TPS40070/71 Errata

1 Parts Affected

- TPS40070
- TPS40071

Figure 1. Limiting the Slew Rate

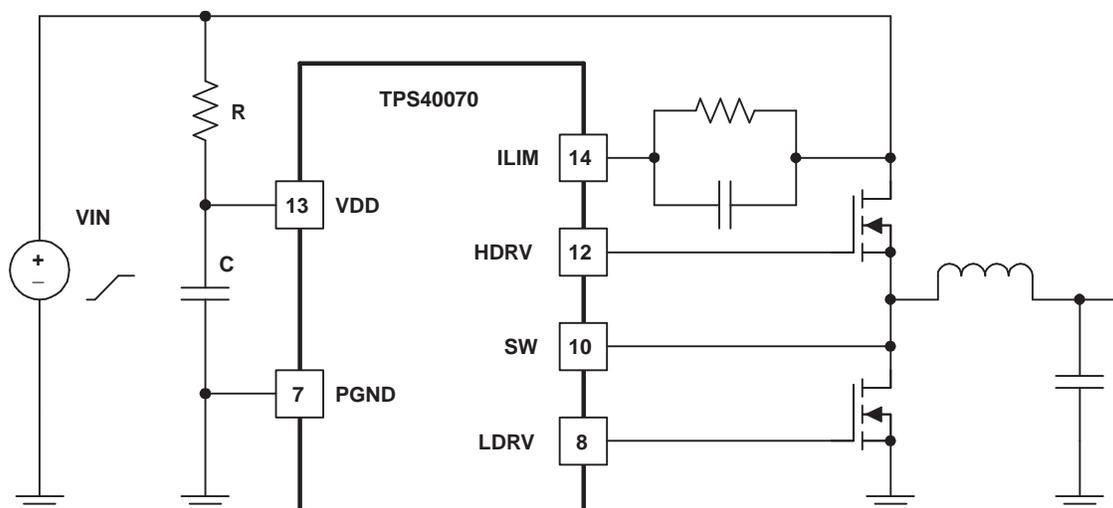
2.7 High Slew Rate Input Voltage can cause Overshoot and Damage the Device

- **Cause:** If input rises too quickly the device's internal 10-V regulator can over shoot which damages the device.
- **Corrective Action:** Add a small RC on the VDD pin of the device. Details can be found in the data sheet.

The regulator that supplies power for the drivers on the TPS40070/1 requires a limited rising slew rate on VDD for proper operation if the input voltage is above 10 V. If the slew rate is too great, this regulator can over shoot and damage to the part can occur. To ensure that the part operates properly, limit the slew rate to no more than 0.12 V/ μ s as the voltage at VDD crosses 8 V. If necessary, an R-C filter can be used on the VDD pin of the device. Connect the resistor from the VDD pin to the input supply of the converter. Connect the capacitor from the VDD pin to PGND. There should not be excessive (more than a 200-mV) voltage drop across the resistor in normal operation. This places some constraints on the R-C values that can be used. is a schematic fragment that shows the connection of the R-C slew rate limit circuit.
